REQUEST FOR INFORMATION

RFI NUMBER	NL-RFI-039				
ISSUE DATE (YY/MM/DD)	April 2, 2011				
PRIORITY	H	X	M		L
REQ'D RESPONSE DATE	April 2, 2011 AM

Hope Bay Mining Project

Subject:	North Dam – Reduced Annulus	Project Zone/Area:	Doris North / Doris
Company:	Nuna Logistics Ltd. (Nuna)	Station/Location:	North Dam
Attention:	Mark Valeriote cc SRK	Discipline:	Civil

~ WHAT HAS BEEN FABRICATED ON SITE (AS OF APRIL 14, 2011)

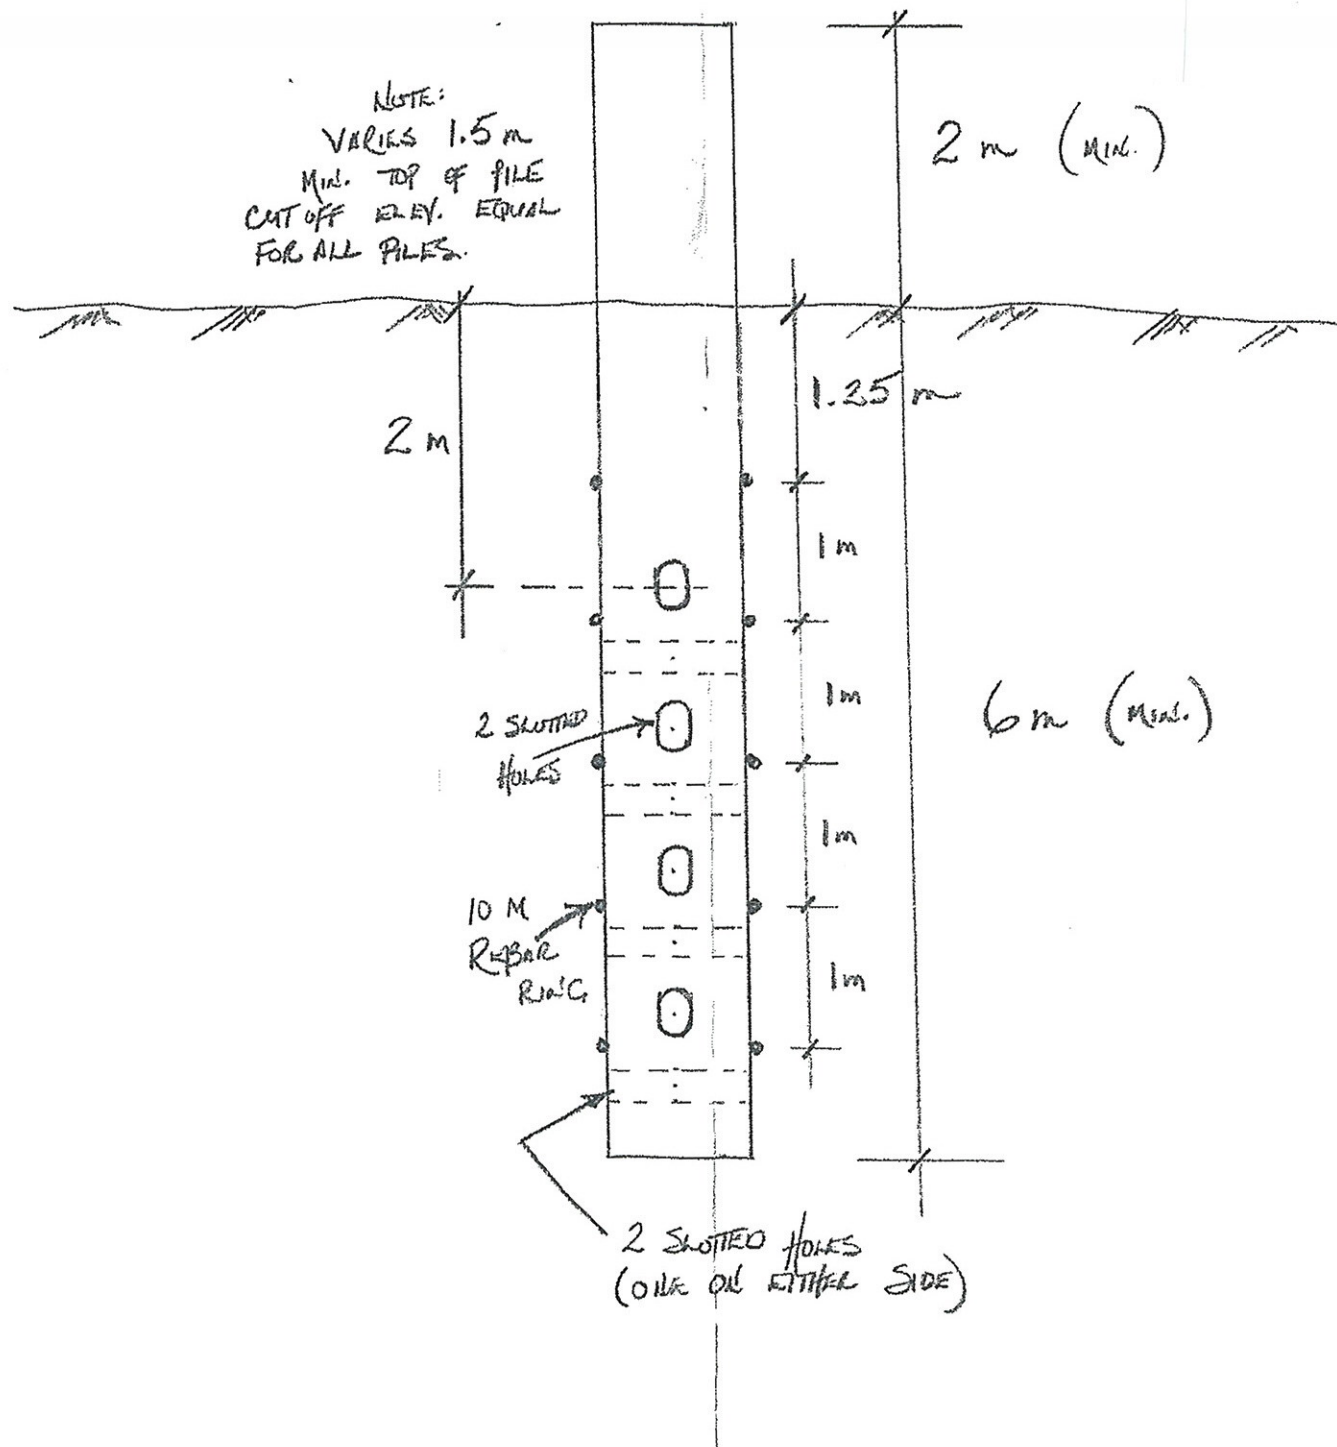
Information Request/Description of Issue/Approval Required:
To reduce further operational delays due to expediting an 8.5" drill bit to site to drill the holes at the vertical support pile locations at the North Dam, Nuna proposes using the 6.5" drill bit currently available on site.
Proposed Corrective Action:
Nuna proposes to drill a 6.5" hole for the piles and reduce the annulus from 50mm to 25mm on either side. It is understood from discussions on this yesterday, April 1 st , between the EPCM, Nuna and SRK that the reduction in annulus would then require the overall pile embedment length to be increased from 6.0m to 7.0m. All other engineered drawing details remain the same.
Originator: KEVIN OAKES
Print: Sign: Date:

1. The embedment depth for a pile utilizing a 25mm annulus would be required to be 7m.
2. Additional slot cuts (4-6) would be required to be cut into the extended pile section and an additional rebar ring would be required on the piles.

3. As the measured dimension of the pile pipe, rebar ring and rebar centralizer was measured in the field to be ~6 ½" some of the existing centralizers (rebar) on the existing piles are expected to be cut.

5. The piles would be extended above ground to ensure that a minimum stick-up of 1.5m above the elevation of the levelling course/ thermosyphon bedding grade is maintained.

Base on field survey information of the WSW thermosyphon trench excavation and the measured length of the previously fabricated piles, the piles are expected to be required to be extended by 2 to 3m in length.

- Final pile lengths are a minimum of 9.5m at the highest point and a maximum of 10.5m at the lowest point (based on neat lines).
- It is recommended that to account for any potential over drilling and to assist with easy welding the c-channels and cross bracing that an additional 0.5m allowance be added onto the piles. Therefore pile lengths are expected to be in the range of 10m minimum to 11m maximum (or extensions are expected to range from 2 to 3m).
